## Product Change Notice (PCN)

PCN Number: **PCN-0451399R-01**

Product(s) Affected: **PJ-063AH & PJ-063BH**

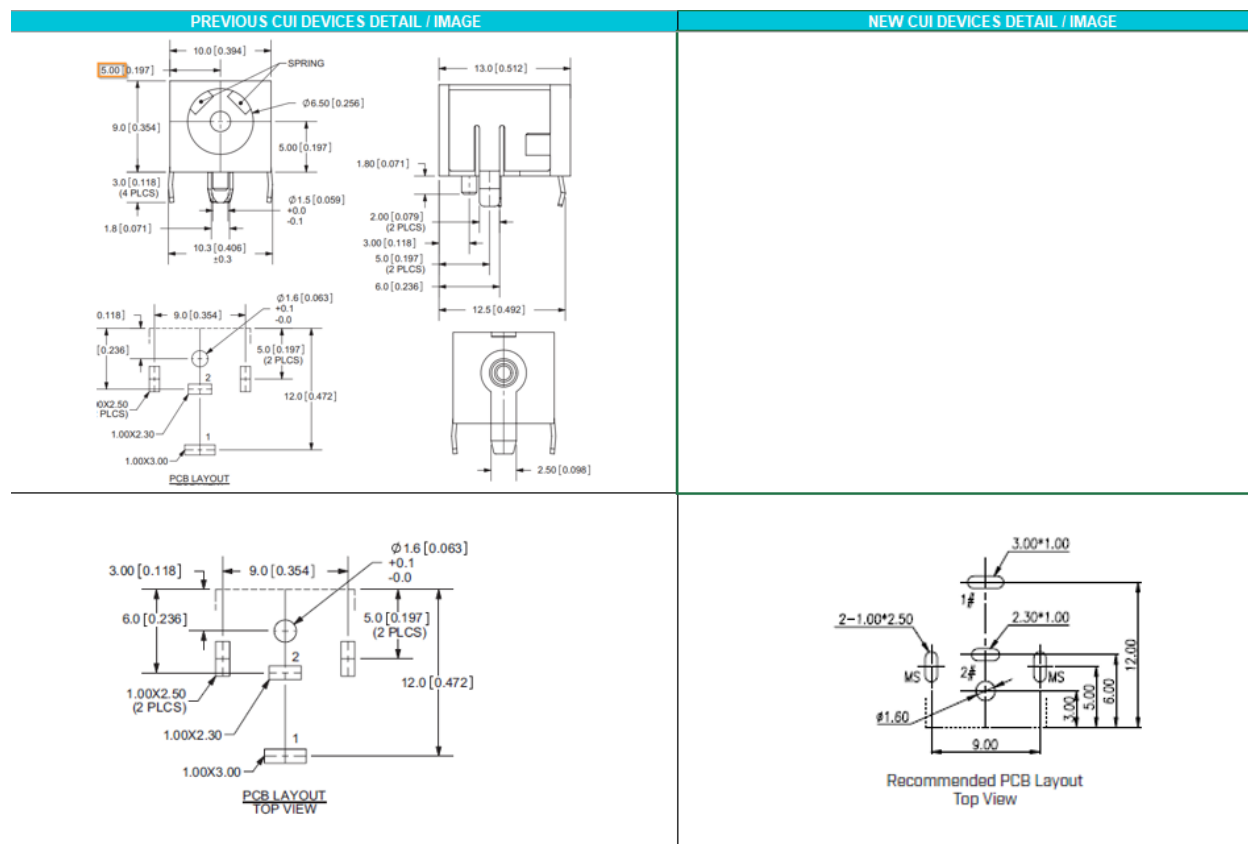
Description of Change: **Mold Change. Cosmetic differences on the mold. Stamping removed ("P" & "Made in China") All measured dimensions on the 2D drawing remain the same.**

PREVIOUS CUI DEVICES DETAIL / IMAGE			NEW CUI DEVICES DETAIL / IMAGE		
	MATERIAL	PLATING			
center pin	copper	nickel	DESCRIPTION	MATERIAL	PLATING/COLOR
terminal 1	brass	silver	center pin	copper	nickel
terminal 2	copper alloy	silver	terminal 1	copper alloy t=0.40	silver
spring	copper alloy	silver	terminal 2	copper alloy t=0.25	silver
shield	brass	nickel	spring terminal	copper alloy t=0.25	silver
plastic	PBT		shield	brass	silver
			cover	PBT (UL94V-0)	black
			housing	PBT (UL94V-0)	black

MATING PLUG  
Jack Insertion Depth: 8.85 mm

MATING PLUG  
Jack Insertion Depth: 8.30 mm
